**North  
Lincolnshire  
Council**

**Barton Link Road  
Consultation Report**

**November 2021**

## Plan 1: A1077/ B1218 Proposed Junction Improvement scheme

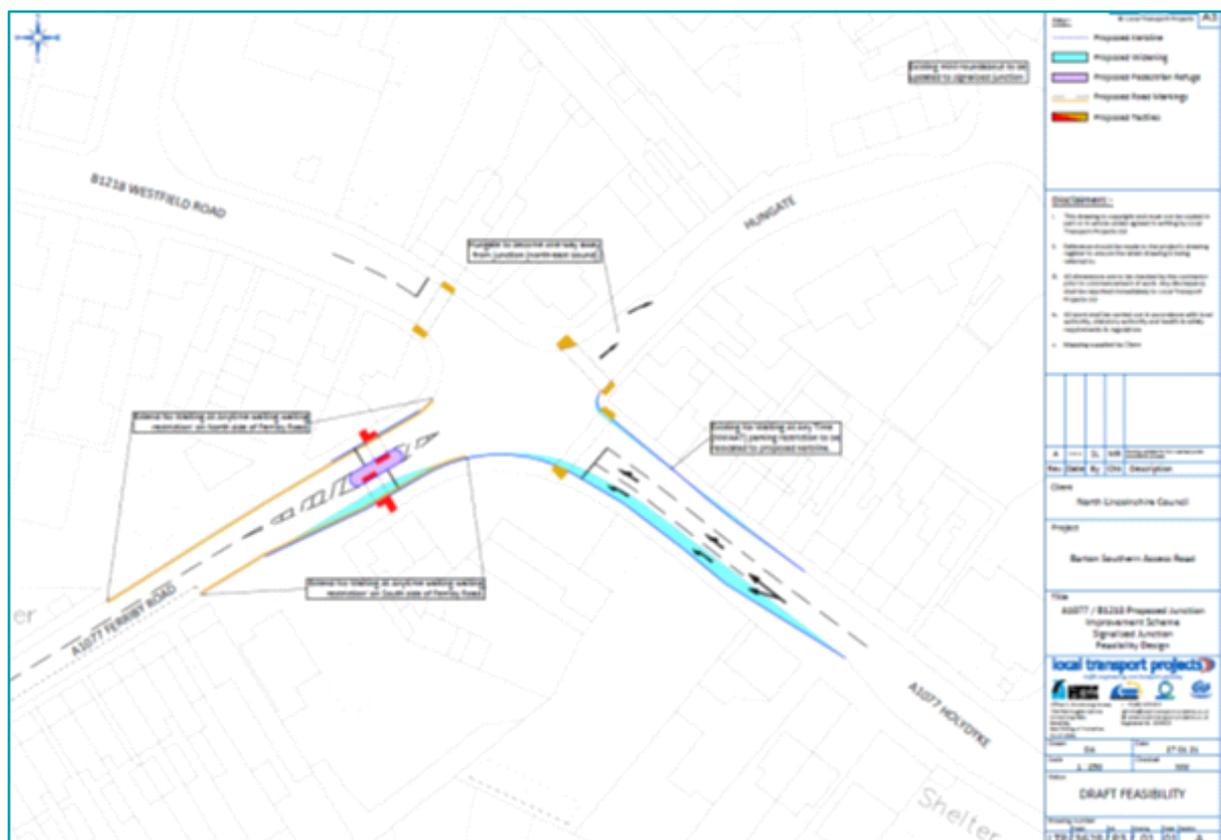
Ref No.	Comments
Electronic Online Responses	
1	<p>Improvements to the bottom of Ferriby road are much needed. The one way system to Hungate will make the junction much safer. Will pedestrian crossings (pelican crossing) be included at the traffic lights?</p> <p>The new junction on the A15 is an improvement to previous plans but will this not require excessive work? The area it joins the A15 is a cutting, so surely blasting will be needed to bring roads to the right level. How will noise for local residents close to the new junction (Horkstow Road and Clipson crest) be reduced during the build and also from traffic after the build?</p> <p>Resurfacing work recently was very disruptive at night to local residents and this was just for one week. Building a new junction will take months.</p> <p>Will land between the relief road and Horkstow Road be classified as green belt so planning for house building can't be granted?</p>

53	<p>The route for the relief road looks very good, makes absolute sense to link directly with the A15. I also think the improvements proposed for the Ferriby Road/Holydyke/Hungate junction make sense.</p> <p>However there are some key pieces of information missing:</p> <p>Will the improvements to the Ferriby Road/Holydyke/Hungate junction be made fairly quickly? When are these improvements planned for? They don't need to wait for the relief road?</p> <p>What is the timeline for the approval, construction and completion of the relief road? Wren's new factory construction is being done very quickly, all the time we are waiting for this the traffic through Barton will increase further. Let's stop the dither and delay.</p> <p>Is the land required available and landowners will sell, or will it be compulsory purchase?</p> <p>What is the cost of the project and has funding been secured? If not, what is being done to secure it and when will this be confirmed?</p> <p>At the previous consultation the plans showed that housing would be built along the route, this isn't shown on these current plans. Has this been removed, or just not shown?</p> <p>Will any development be residential only, or will there be commercial development, another primary school or anything else?</p> <p>All in all, a good route, but for me doesn't answer all the questions</p>

108	<p>Happy with the relief road proposal.</p> <p>Ref A1077 proposal. Making Hungate one way, widening the road and not having HGV's negotiating the junction will dramatically reduce any congestion and confusion at this roundabout. In our experience for much of the day traffic already flows smoothly and these changes will help even more. However to add in 3 way traffic lights in my opinion would lead to more congestion and frustration that exists at the moment,</p>
109	The revised plans May 2021 in my opinion look good and will be just what Barton needs. One comment I would make is there needs to be a weight restriction through the town from Barrow Road to Ferriby Road top. I would like to see better traffic management at Blue Bell junction such as 4-way traffic lights, however if traffic numbers are reduced by the relief road this may not be entirely needed. I assume there will still be access for walking up Eastfield Road south bound, as very popular for walkers.

**Plan 2: Proposed A1077 Barrow Road/ Falkland Way Roundabout**

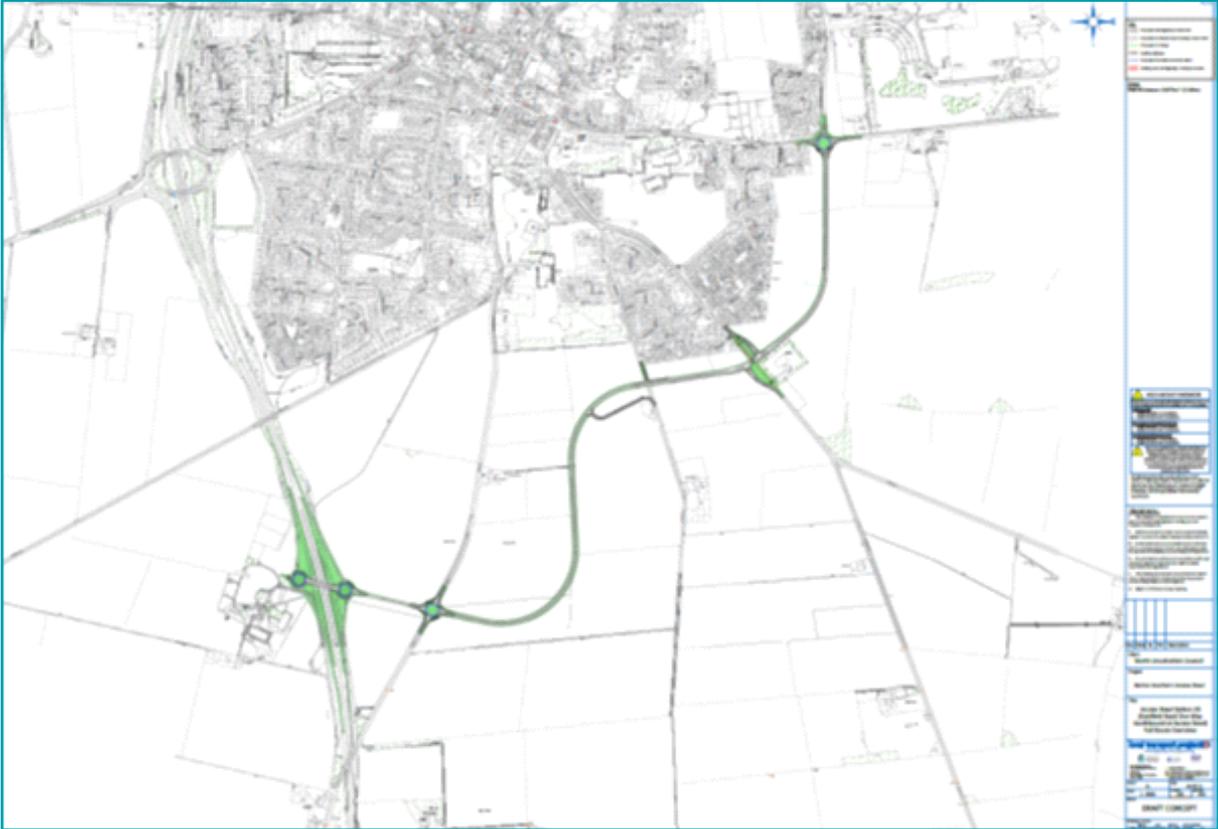
41	I am all for the relief road, as the town was not built for the amount of traffic passing through and cannot wait for it to be implemented. I have one concern however on seeing the proposed plan for the top of Falkland Way. My concern is that on a morning when I have to head to Barrow, at peak times I am going to have no chance of getting across the roundabout, as all Wren staff is going to be coming in on the relief road and turning right, there will also be reduced traffic coming in off Barrow Road, due to the new Wren entrance, reducing my chance of getting across the roundabout even further. It would be preference for the junction to be traffic lights, this would then also give the Wren staff, coming in from the Barrow direction, chance to get across the road into the new Wren entrance, reducing any blockages on Barrow Road and reducing any chances of accidents, with the junction being so close to the corner and the waiting box only being able to hold a small number of vehicles.

60	<p>I feel having the new roundabout placed at the top of Falklands way is going backwards and wouldn't solve any problems. It is placed too close to residential properties and it will not ease the traffic problems currently happening with fewer cars on the road nevermind when the new factory opens. I think the relief road plans worked better with the first set of plans (where the road was further out of Barton) the road seems to run very close to houses, with the road been a 24/7 commercial bypass this will ruin current home owners quality of living. Also having the road so close to the current boundary of Barton restricts and more growth and development of the town.</p>

279	<p>1. Rather than a roundabout at the top of Falkland Way, how about a box junction with traffic lights and pedestrian crossings. Lots of children crossing the A1077 to the new estate, and the nearest crossing is at the Blue Bell.</p> <p>2. Traffic lights will also slow the traffic coming from Barrow into Barton along the A1077 as the 30mph sign as you enter Barton is ignored by a lot of drivers.</p> <p>3. Hopefully people won't cut through and come speeding up/down Caistor Road as they use it as an alternate route to get to the B1206.</p> <p>4. The proposed plans, if the lorries actually use the new road and by pass Barton/ Market Place instally is excellent and has our full support. Good Luck.</p>
280	<p>1. Whilst on the works: Could it be possible to turn the grass verge on the right had side of Ferriby road (heading uphill) to car parking for the people on Ferriby Road, and make it double yellow lines for the whole of the current, bottle necked due to parked cars.</p> <p>2. Give them permits to park and make it permit holders only if need. Also a general observation for almost all the town these days.</p> <p>3. Pavements could be made narrower to allow wider roads in many places. Not many people are for these days. Especially on residential streets. Make it much easier to get about.</p>
